BLM SCALAR FIX -Based on findbhudda's original design:
<http://www.midibox.org/dokuwiki/doku.php?id=findbuddha>

Corrected blm-scalar v1.1.brd bellow & attached [blm-scalar_v1.1.brd.zip](#)

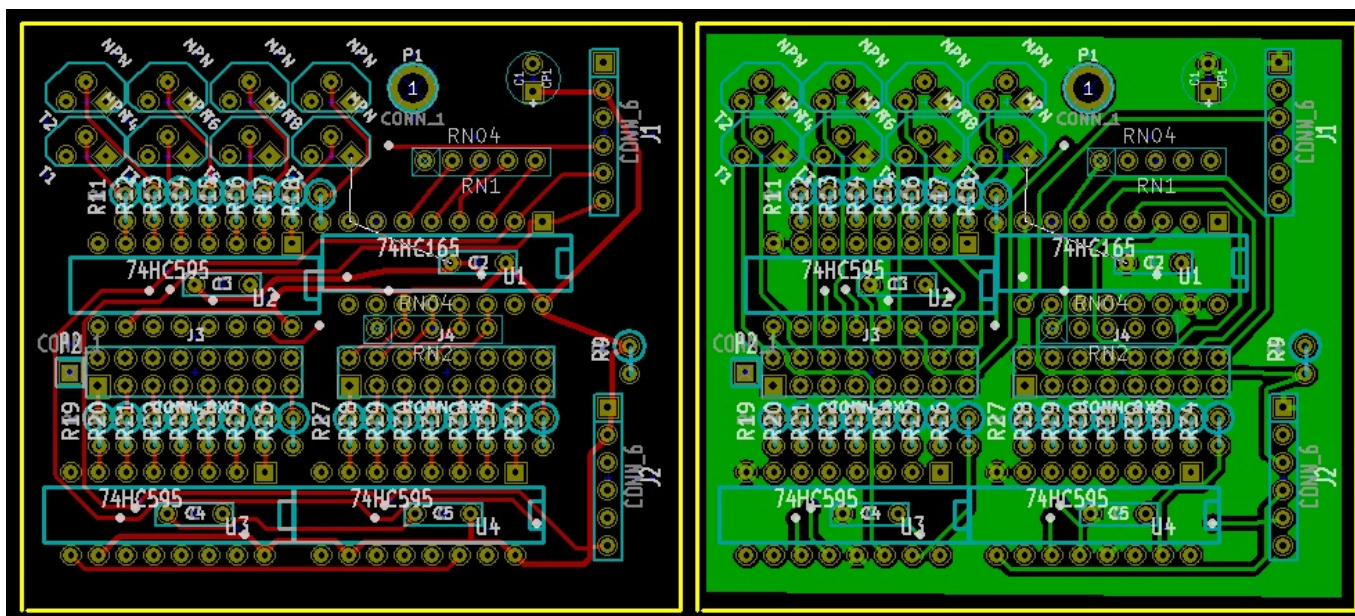
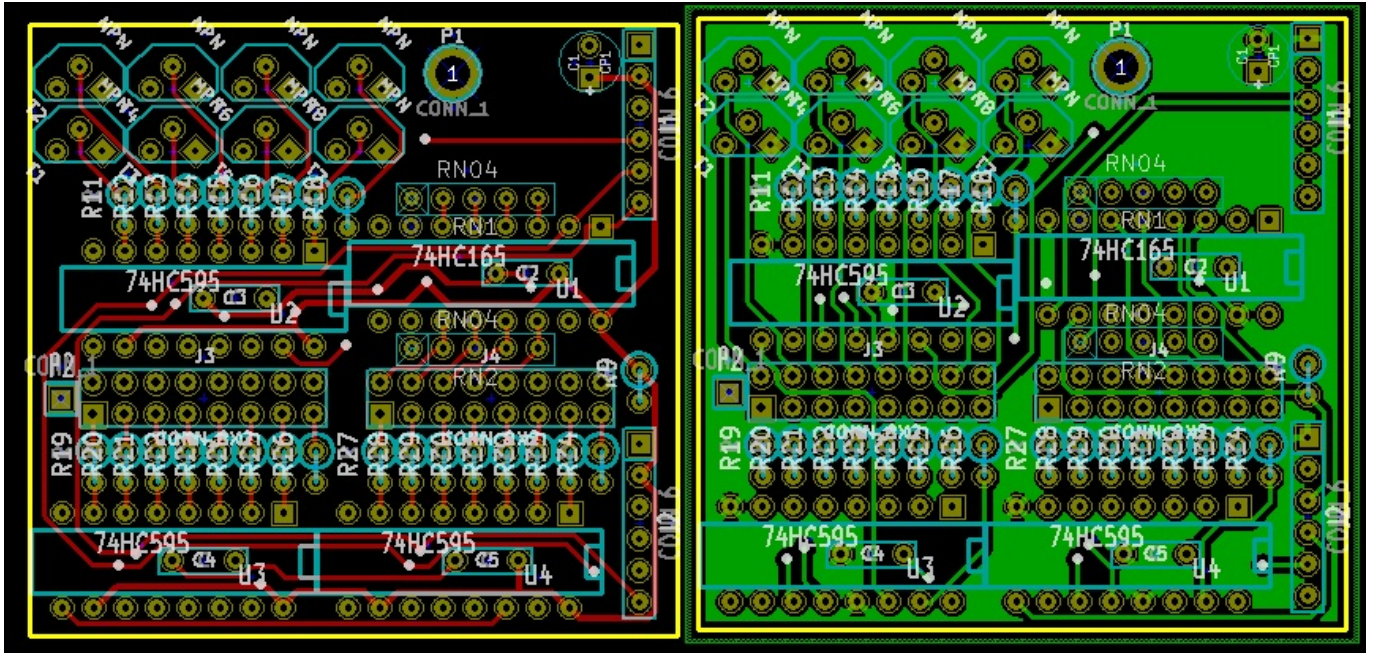
- blm-scalar.* contain an error. Pins I4-I7 are mirrored. This is easily fixed with a connector modification, and the blm-scalar module seems to work as intended.
- blm-scalar v1.1 attempts to fix this error. Moved connectors J1, J2, Resistor Net 1 and R9 to make room for corrections.
